| Project | IEEE 802.16 Broadband Wireless Access Working Group < http://ieee802.org/16 > | |
| Title | Comments on new Multicarrier text in SDD | |
| Re: | Call for Comments and Contributions on Project 802.16m System Description Document (SDD) | |
| Abstract | This contribution addresses the newly added multicarrier text in sections 11.6.4 and 19 of the 802.16m SDD. | |

Figure 1 Sub-carrier alignment by applying a fraction of sub-carrier spacing to the FA of adjacent frequency channel

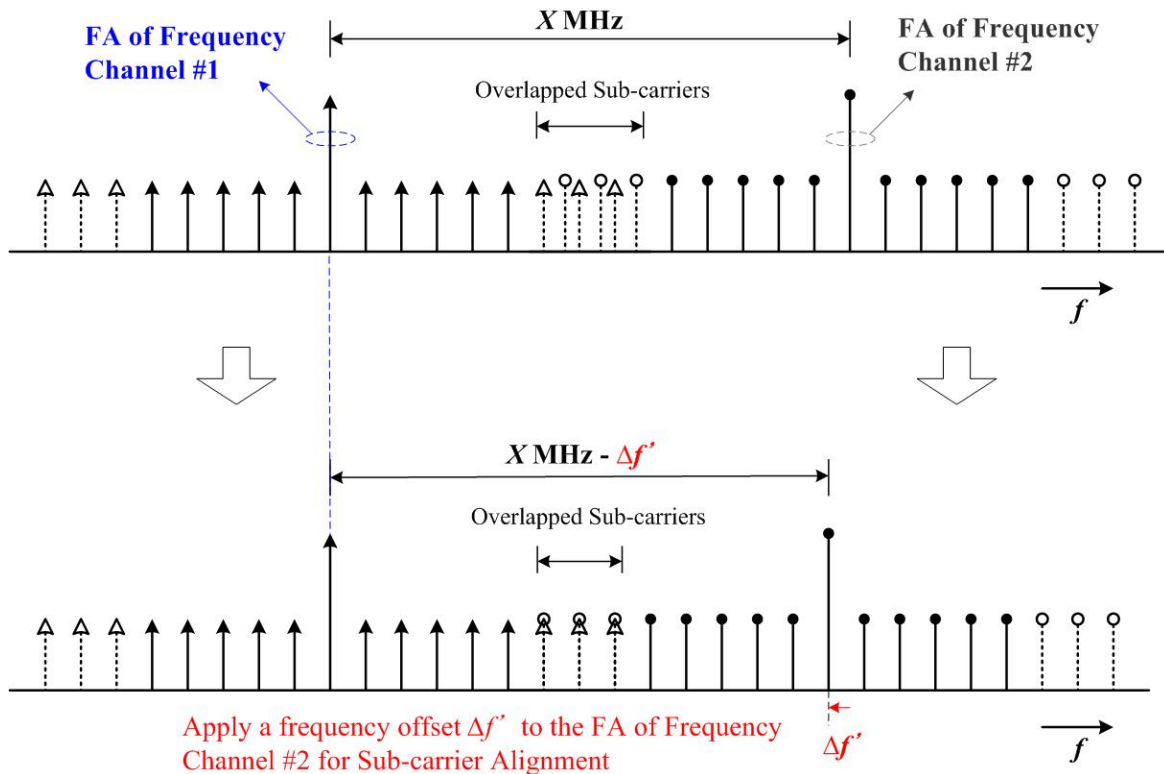
Finally, the opening text of section 19 is for a very specific boundary case of using the guard subcarriers of two adjacent carriers. It should not be the opening text of section 19, but should be a subsection of section 19.

Move the opening text starting here and ending just prior to section 19.1 into a new section “19.2 Utilization of guard sub-carriers of adjacent frequency channels”.
